SITE NOTICE

Consent No: **20251668** Date Printed: **9 April 2025**
Owner: **K E Marshall and K T Mahuika**
Site Address: **15A Clyde Road Riccarton**
Legal Description: **Lot 2 DP 41440**
Work Type: **Alteration to dwelling - installation of Masport Rakaia (ULEBS), dry, freestanding, woodburner, CAC-200855**
Email To: **jorjam@extra.co.nz,qualitycleans@xtra.co.nz**

Inspection Type: **232 - Heating Unit Final (Sld or Liq Fuel Heater)**
Inspection Outcome: **Pass**
Inspected By: **Brendan Rosetta**
Inspector Mobile: **0272872484**
Inspector Email: **Brendan.Rosetta@ccc.govt.nz**
Inspection Date: **9 April 2025**

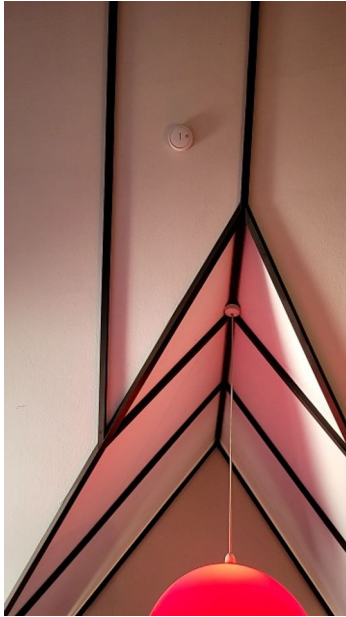
Operational battery operated wireless interconnected ceiling smoke alarms identified

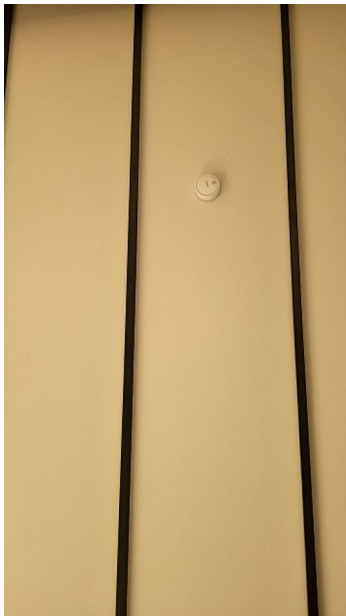
Sloping ceiling considered.
Taken at 3:40 PM on Wednesday 9/04/2025
